CITY OF ALBUQUERQUE

RE: 13708 Poinsettia Place SE
Grading and Drainage Plan
Engineer's Stamp Date: 1/17/23
Hydrology File: L23D001E

ENGINEER'S SEAL	LOT 5 BLK 1 N FOUR HILLS SUB 13708 POINSETTIA PLACE SE	DRAWN BY DEM
DAVID SOULE 14522 REGISTERED PROFESSIONAL ENGINEER	GRADING AND DRAINAGE PLAN	DATE 11-15-23
11/19/23	Rio Grande Engineering P.O. BOX 33924 ALBUQUERQUE, NM 87199 (505) 321-9099	Job 5 Blk 1 N Four Hills Sub. DWG
DAVID SOULE P.E. #14522		SHEET # C1
		JOB #

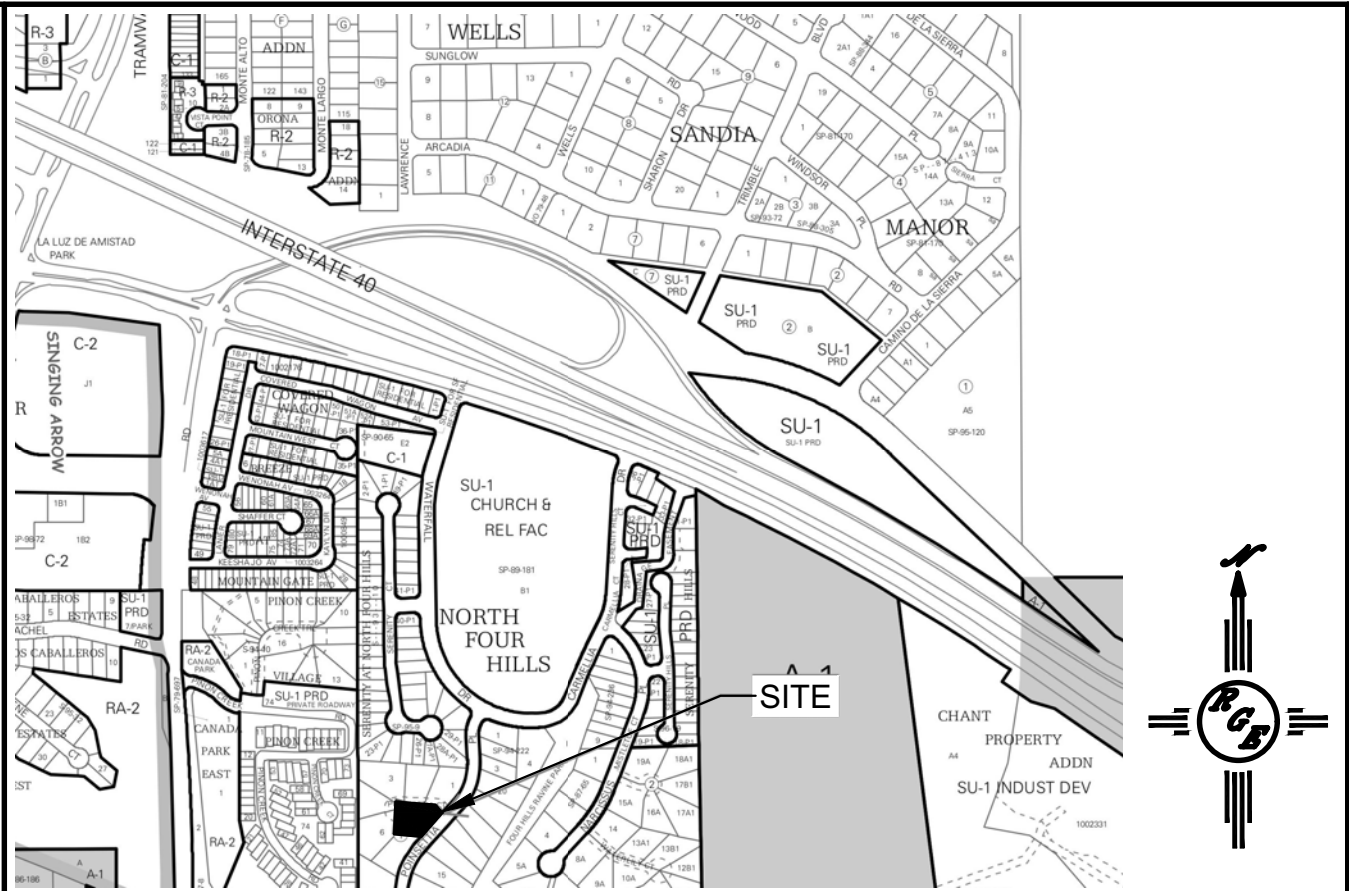
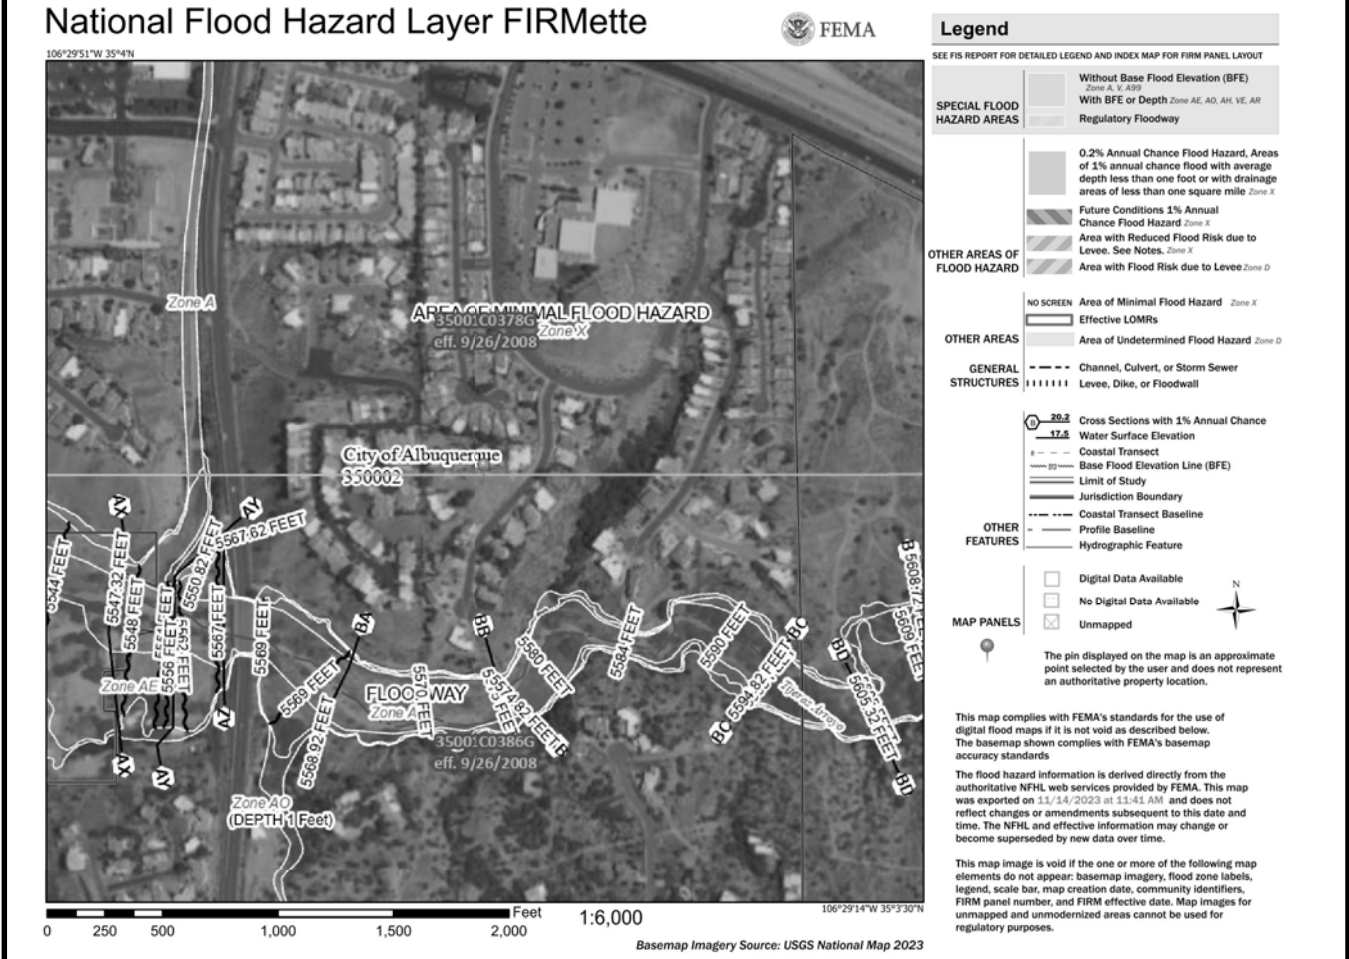
Based upon the information provided in your submittal received 11/20/2023, the Grading and Drainage Plans are approved for Building Permit and Grading Permit. **Since this site has stem walls integrated in the building, a pad certification is not needed for this project.** Please attach a copy of this approved plan in the construction sets for Building Permit processing along with a copy of this letter.

1. Engineer's Certification, per the DPM Part 6-14 (F): Engineer's Certification Checklist For Non-Subdivision is required.
